Seismic Walkdown Checklist (SWC)

Equipment ID No DC-1-23-M-BF-S-31

Equipment Description: Aux. Bldg Ventilation Supply Fans

Diablo Canyon Power Plant, Unit 1

Attachment 1, Page 3 of 4

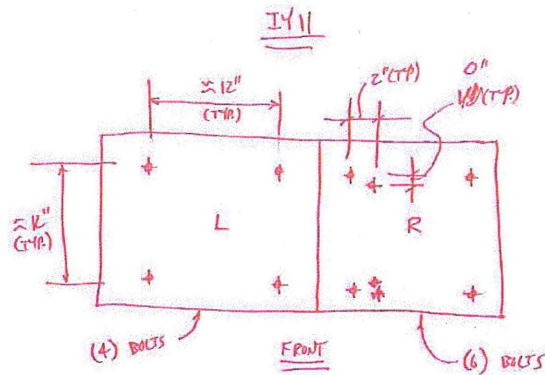
- Perform an Extend of Condition review to determine if other similar transformers are impacted
- Revise calculation no. ES-68-1 to address the as-found condition
